ARCHITECT'S ADDENDUM NO. 1
REVISION OF DRAWINGS & SPECIFICATIONS

PROJECT:
NEVADA DTR
NEVADA, IOWA

TO: ALL BIDDERS
DATE: 06/05/2026
FROM: Curtis Architecture & Design P.C.

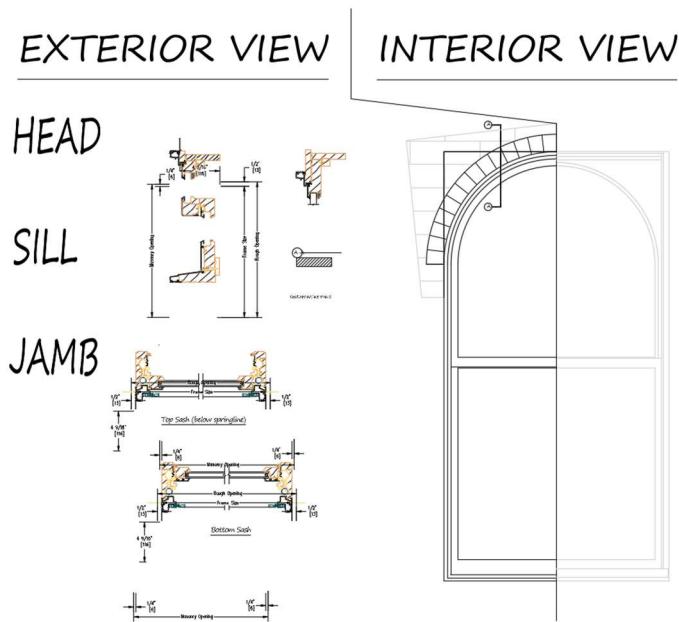
7. Over or under ground joints and gouged bricks are not tolerated. Appropriate tools shall be used. Any and all gouged brick will be replaced in-kind at the expense of the contractor. Size and texture must match; color, if not matched, must be stained or painted to match the surrounding context. An appropriate tuckpointing grinder should be used. Piping bags are recommended for repointing. Mortar should match color and composition of the mortar tests available in the specification booklet. The mason is expected to provide a 2'x2' test area prior to repointing to be approved by the architect.
8. 1038 6th St., 526 K Ave., & 532 K Ave.: Provide repointing of all stone coping. Coping removed for brick relayment must be reinstalled and repointed.
9. 1028 6th St.: Door opening schedule is labeled 526 K Ave.; this is a title error, the information in the table is correct. See Below.
